South Texas Project Electric Generating Station P.O. Box 289 Wadsworth, Texas 77483

August 10, 2009
U7-C-STP-NRC-090090

South Texas Project
Units 3 and 4
Docket Nos. 52-012 and 52-013
Supplemental Response to Request for Additional Information and
Responses to Requests for Additional Information

RAI 02.05.02-19, Supplement 1

Figure 2.5S.4-16 Corrected CPT Tip Resistance (qt)(STP3)

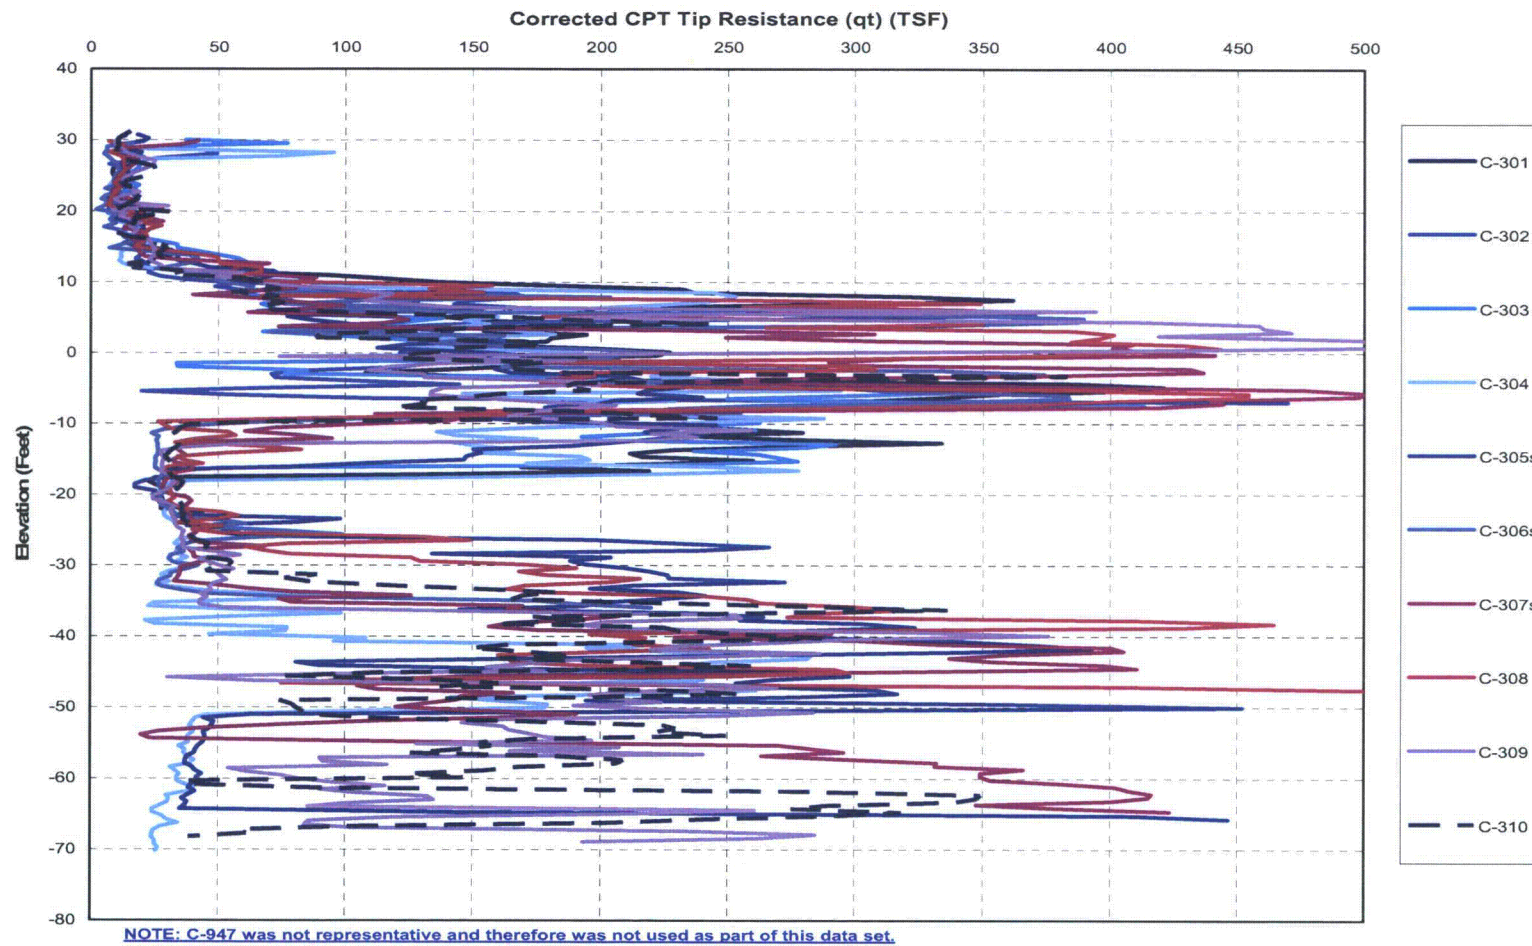
In FSAR 2.5.4.8, "Liquefaction", the results of liquefaction analyses based on STP N-values, CPT tip resistance and shear wave velocities were presented in some detail for factors of safety less than or equal to 1.1. In view of the small number of data points having factors of safety of less than 1.1 that will remain after construction, you concluded that liquefaction potential was nil. In response to RAI 2.5.4-5, you stated that graphic presentation of liquefiable zones below power block safety related structures was not possible because there are no liquefaction zones. Regulatory Guide 1.198, Section 3.2, "Factor of Safety Against Liquefaction", recommends that for factors of safety less than 1.1 and factors of safety between 1.1 and 1.4, that stability and deformation analyses should be performed with assigned strength values commensurate with the amount of pore water pressure generation. Your presentation in the FSAR does not address strength degradation for factors of safety between 1.1 and 1.4. Without a detailed explanation of those results, the liquefaction and/or strength degradation issue is not fully addressed. The staff needs the following information and data to close out this issue.

Corrected CPT q_t tip resistance profiles versus elevation are shown on Figure 2.5S.4-16, 2.5S.4-17, 2.5S.4-18, and 2.5S.4-19 for the STP 3 area, the STP 4 area, the area west of the Power Block, (now outside the Power Block), and for the remaining area outside the Power Block, respectively. CPT data from all 10 CPTs made within the STP 3 area, all 11 CPTs made within the STP 4 area, all 10 CPTs made within the area west of the Power Block (C-947 was excluded due to erroneous data), and the one CPT made within the remaining area outside the Power Block were evaluated for liquefaction potential. For completeness, all CPT values, including those measured in clay soils and those measured in soils above the groundwater level, were initially included in the FOS calculation spreadsheet, despite their known high resistance to liquefaction. The CPT method identifies clay soils by their soil behavior type index, I_c , and no FOS is calculated for clay-rich soils. The spreadsheet also is set to identify soils above the water table, and no FOS is calculated for soils above the water table.
